Addendum #2 – November 4, 2020

2020.11.04-PSD7Schools_FireAlarmReplacement_Add2_Plans (10 pages)

ISSUES & REVISIONS:		
NO.: 1	DATE: 11/04/2020	BY: TGS
DESCRIPTION: ADDENDUM 2		
NO.:	DATE:	BY:
DESCRIPTION:		
NO.:	DATE:	BY:
DESCRIPTION:

PROJECT:
FORT COLLINS HIGH SCHOOL
3400 LAMBKIN WAY,
FORT COLLINS, CO 80525

FA000

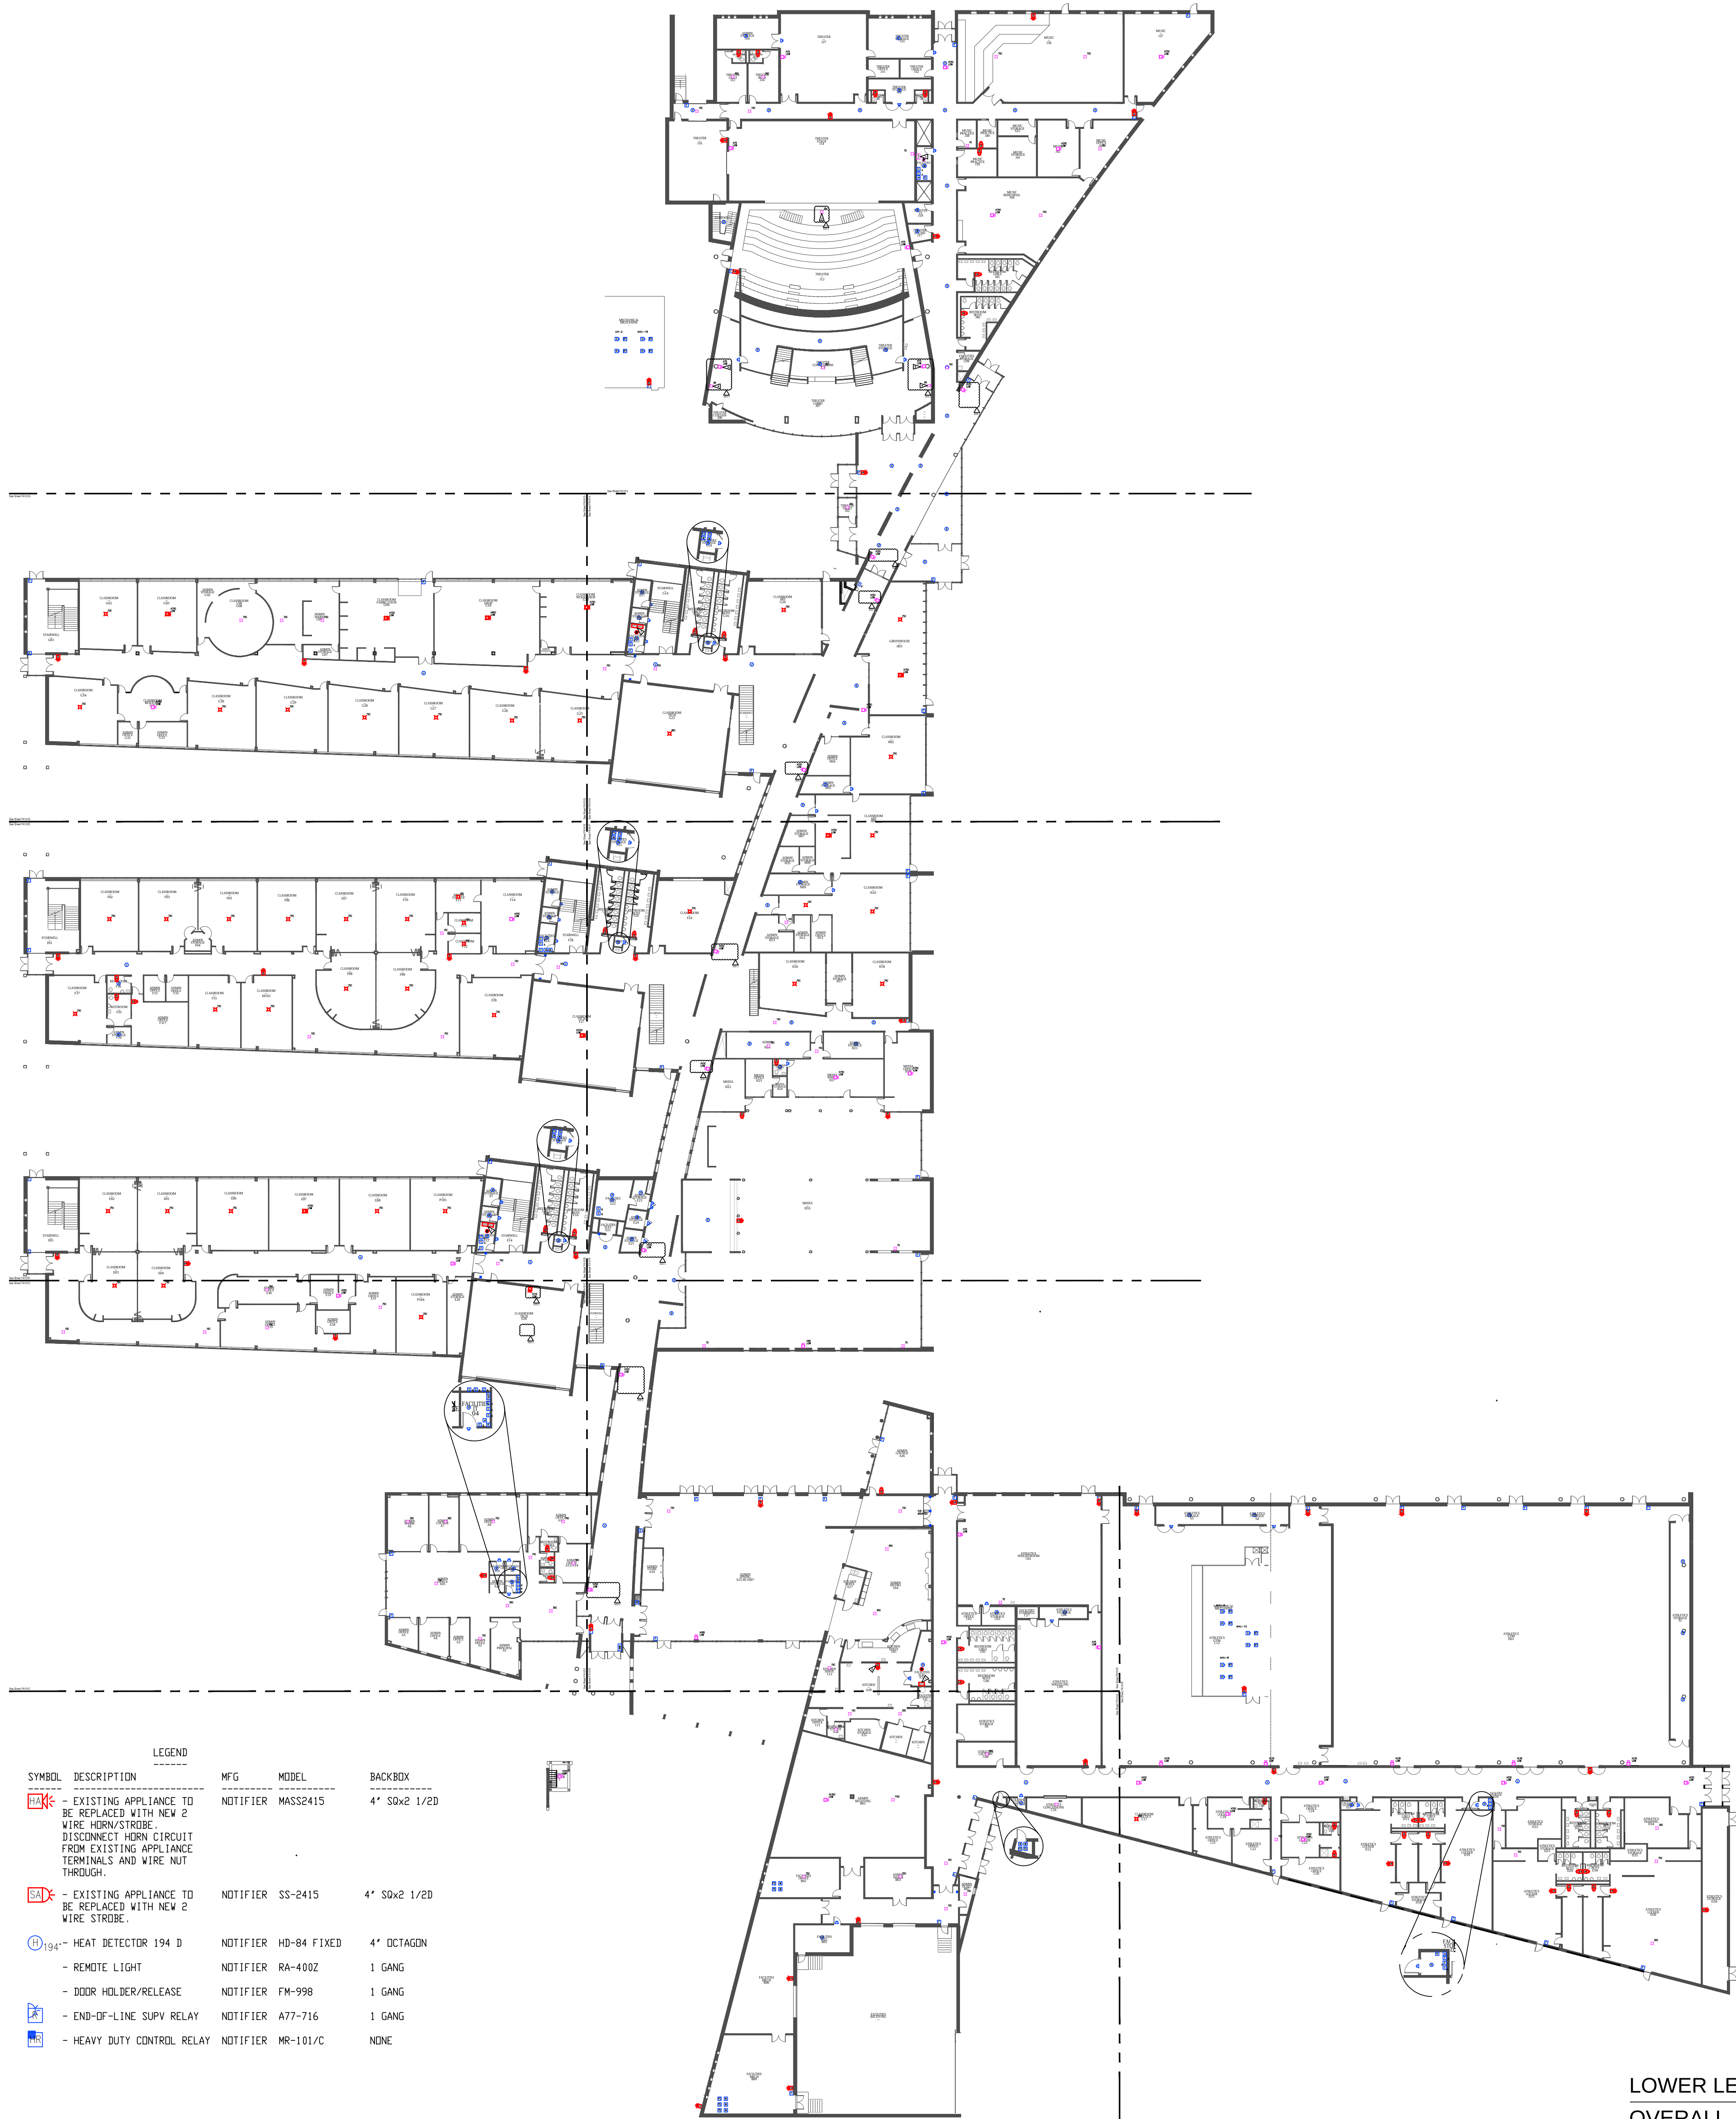
1. Add "Locations shall be field coordinated and approved by PSD" to section 2 of the scope of work.
2. Add section 5, "Provide and install relays to shut down gym, cafeteria and auditorium sound systems and turn on auditorium lights" to the scope of work.

3. Add section 6, "Provide accurate record drawings which include existing notification devices present at each facility that may not be shown on the bid documents" to the scope of work.

4. Remove sub-section C "~~Provide and install FACP web card~~" from section 1 of the Alternates.
5. Remove sub-section K "~~Ethernet communications (NWS-3): provide ethernet topology data communications module (LAN) that shall transmit all control panel off normal condition, including alarm, water flow, supervisory, or trouble via email. The LAN module shall utilize a category 6 rj45 data ethernet connection port for interconnection to the district LAN/wan network. The LAN module shall support remote web browsing and email alert functions~~" from section 1 of the Alternates.

6. Add "If the contractor elects to utilize spare circuits for new speakers, megger testing is required to verify circuit integrity" to section 2 of the Alternates.

7. Add "Programming by PSD" to section 3 of the Alternates.
8. Add alternate 5 "Provide and install new wire for visual notification appliance circuits."

9. Add alternate 6 "Provide and install new wire for audible notification appliance circuits."
10. Revise text indicating fully sprinklered conditions at Lincoln MS from "Yes" to "No".

SHEET NAME:
FC.FAO101

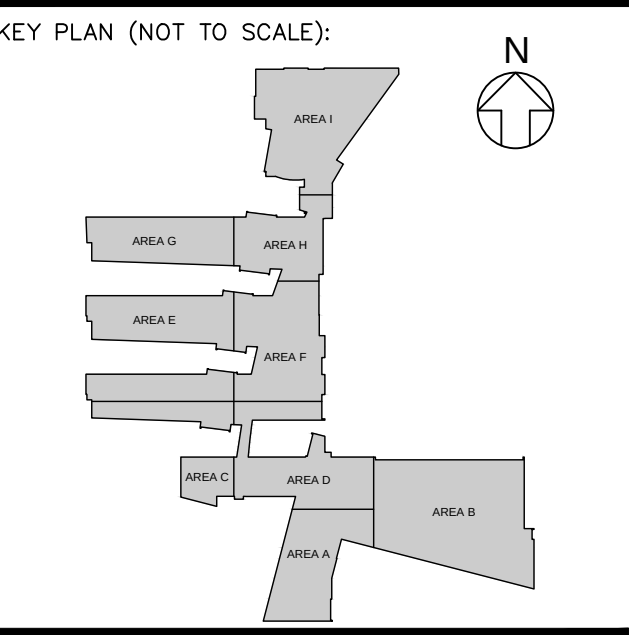
1. Relocate horn/strobe appliances in the main corridor from ceiling mount to wall mount.
2. Relocate ceiling mounted horn/strobe in Classroom Tech E28 to be wall mounted.
3. Add strobe to the pit with flag note 3 "Install notification appliance in pit."
4. Add 95cd wall mounted strobes to the first floor Theatre Lobby J07 with flag note 4 "Install notification appliance on first floor."
5. Add flag note to wall mounted horn/strobes on the second floor near Theatre Lobby J07 with flag notes 5 "Install notification appliance on second floor."

SHEET NAME:
FC.FAO102

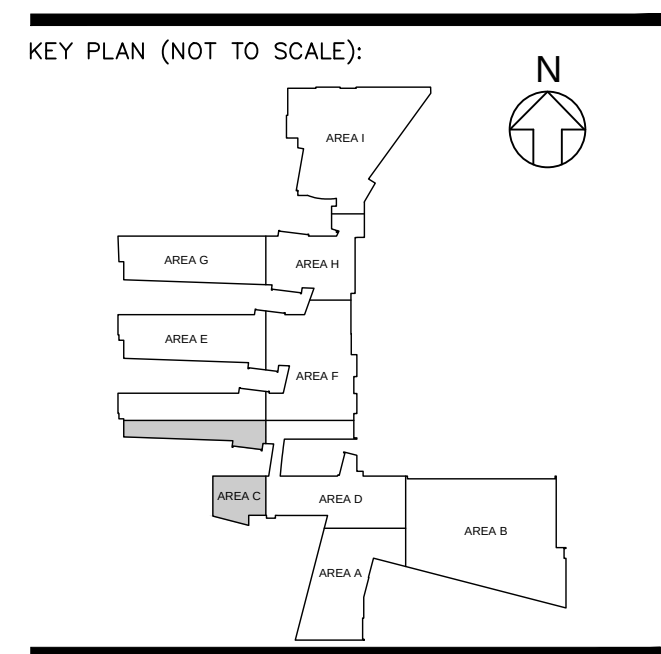
1. Relocate horn/strobe appliances in the main corridor from ceiling mount to wall mount.

FC.FA101C

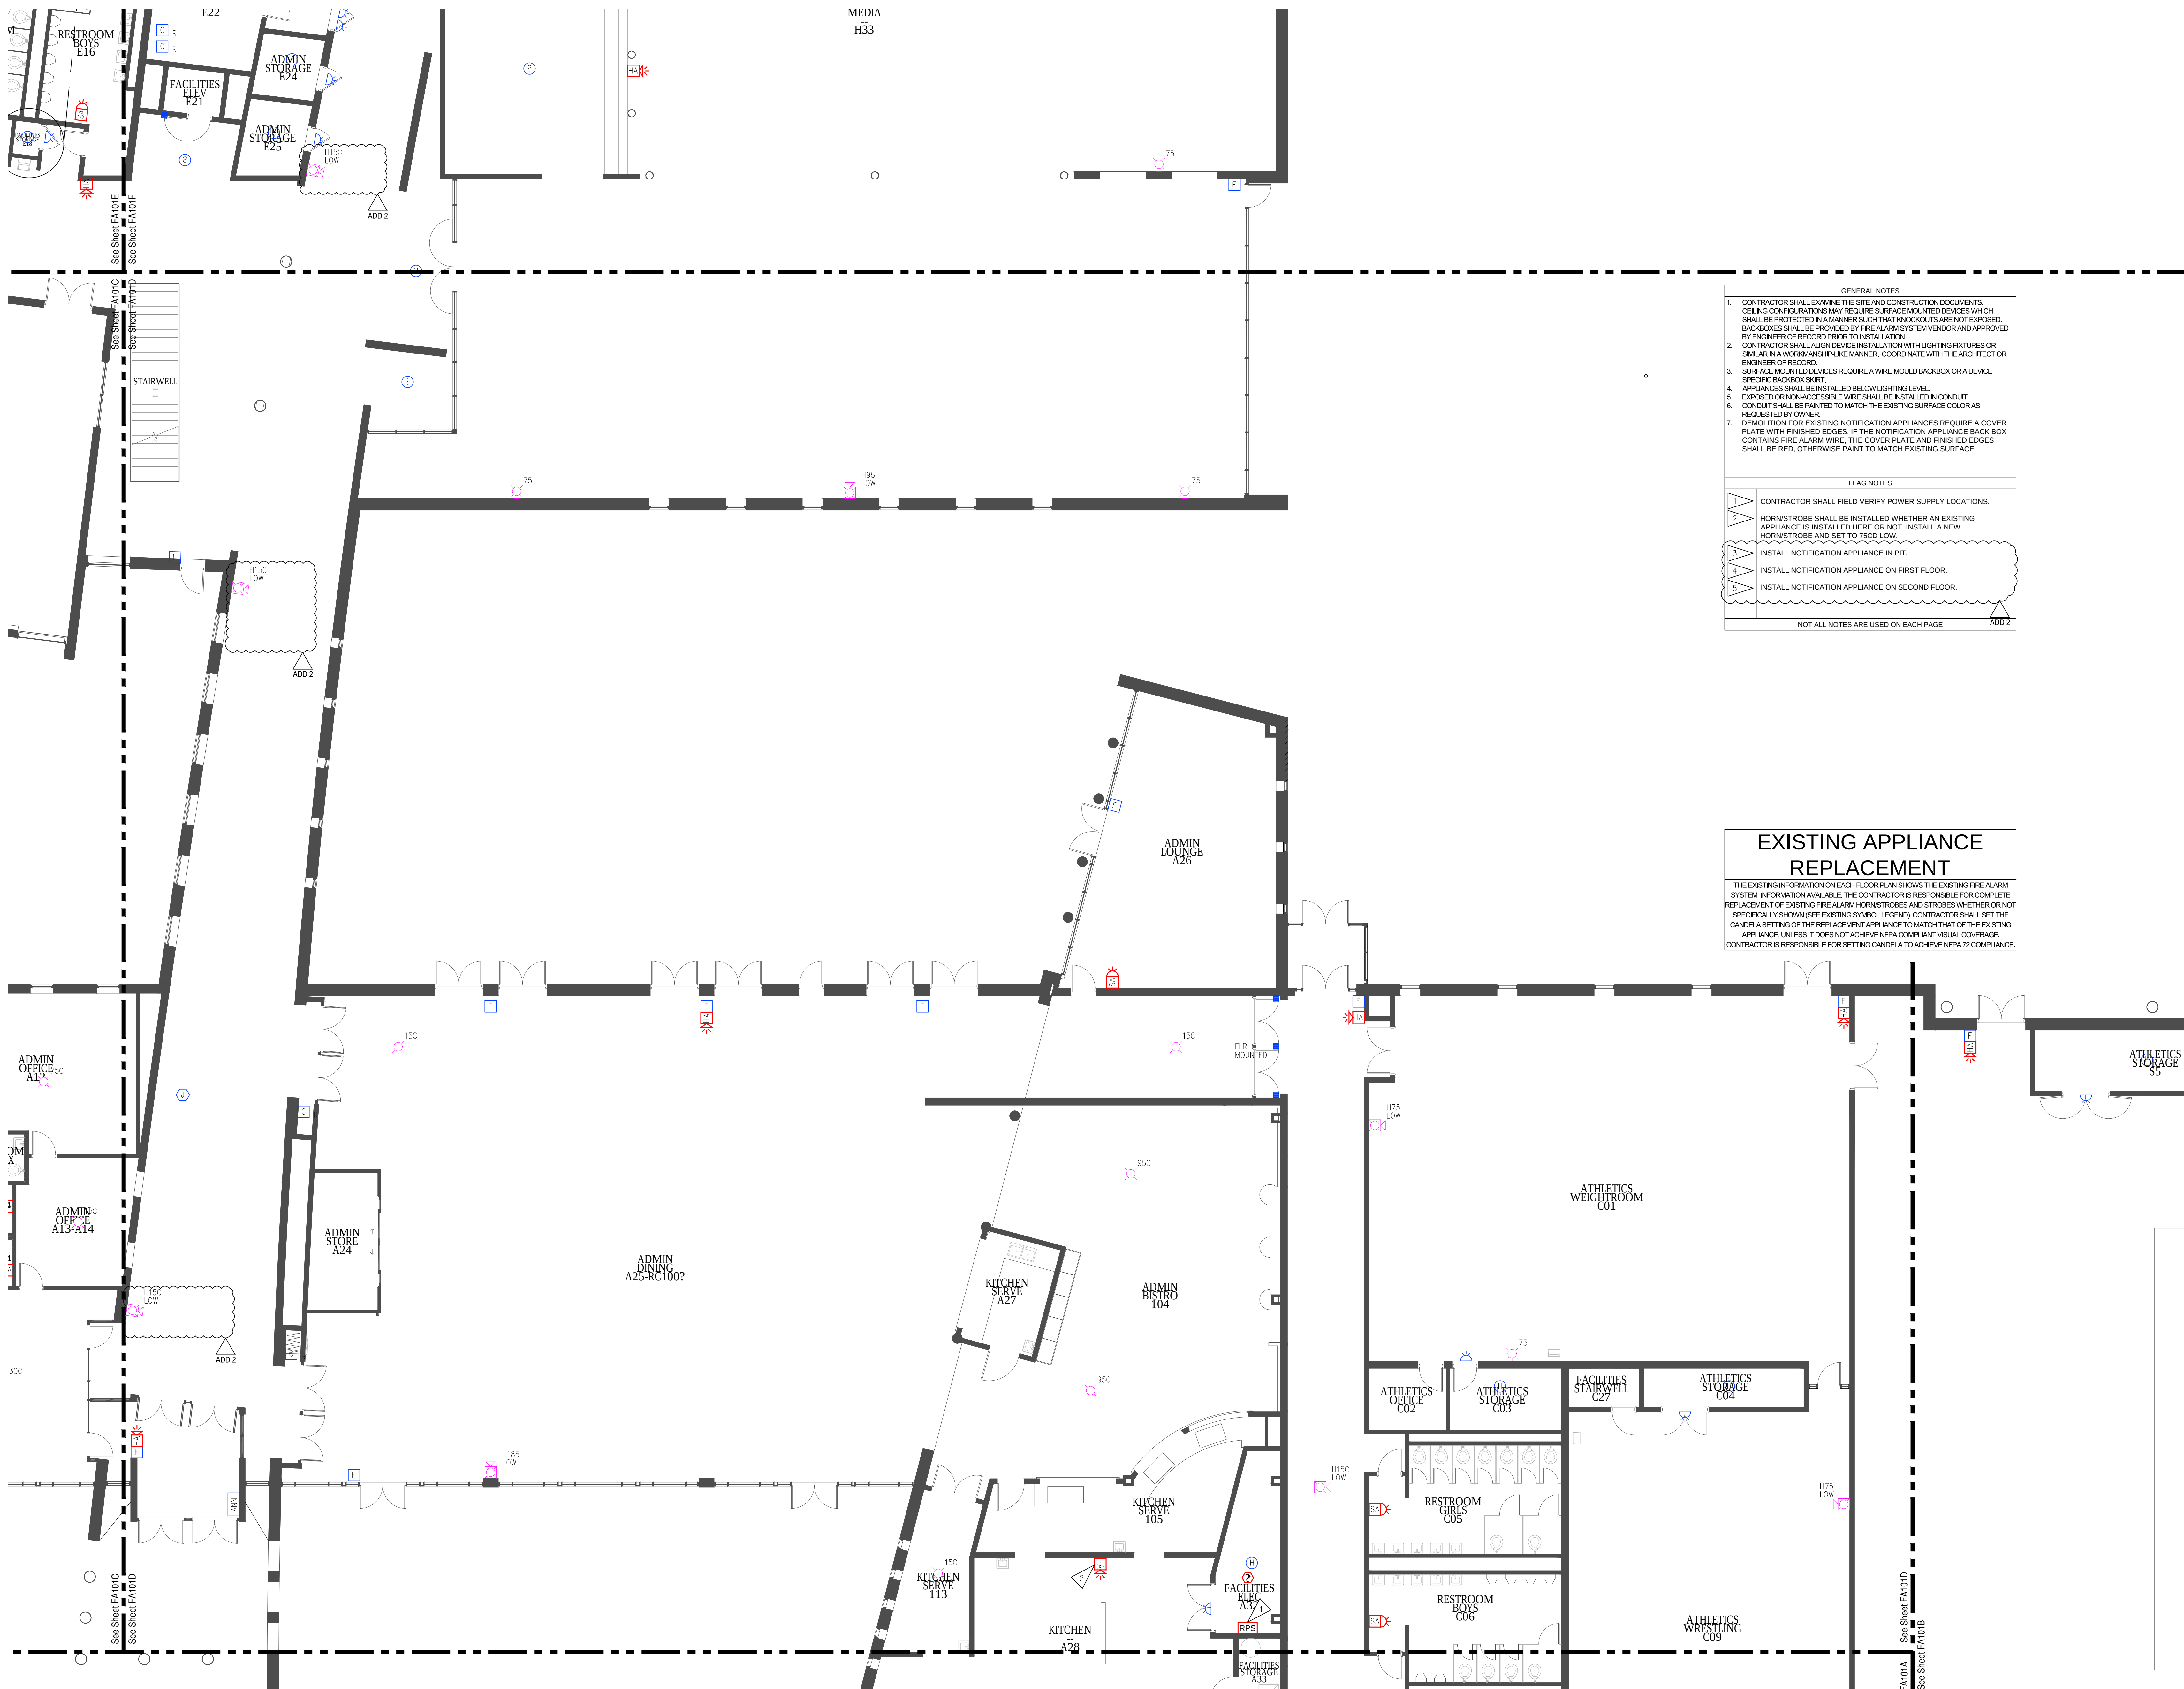
1. Relocate ceiling mounted horn/strobe in Classroom Tech E28 to be wall mounted.
